Circular No. 6/2003
Code of Practice on the Design and Construction
of Lifts and Escalators (2000 Edition)
Amendment No. 4
Code of Practice for Lift Works and Escalator Works (2002 Edition)
Amendment No. 2

**Code of Practice
on the Design and Construction of
Lifts and Escalators
(2000 Edition)**

**Amendment No. 4 of 2000 Edition
Minor Changes/Corrections**

Fig.1 Illustrative Elevation of an Escalator's Dimension Requirements

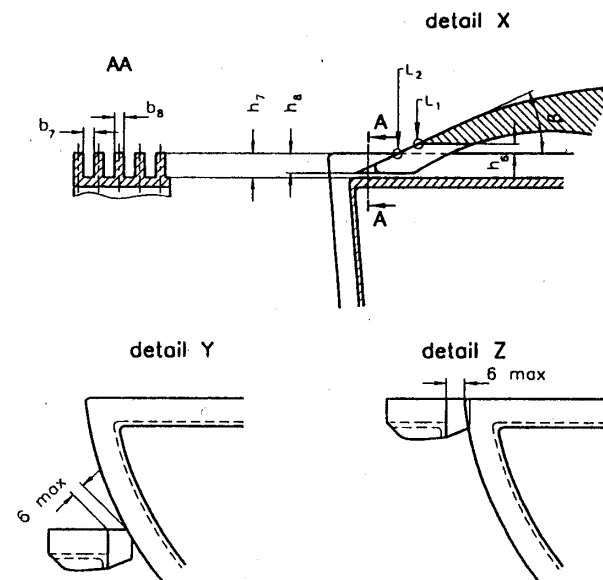
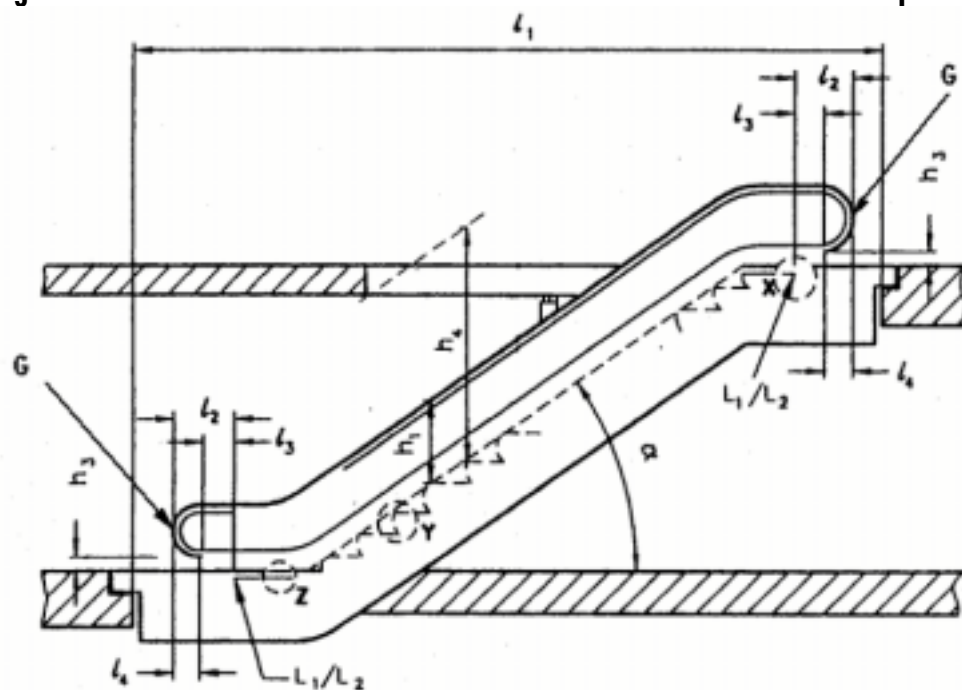
<u>Item</u>	<u>Clause</u>	<u>Description</u>
1	Section E Part 1 Clause 11.2.4 (f)	Replace "WHEN THERE IS A FIRE DO NOT USE THE LIFT" by "IN CASE OF FIRE DO NOT USE THE LIFT".
2	Section E Part 4 Clause 8.6.4	Replace "in all other operations" in the 2 nd sentence by "In all other operations".
3	Section E Part 4 Fig. 1 & Fig. 2	Replace current Fig. 1 and Fig. 2 by the attached Fig. 1 and Fig. 2.
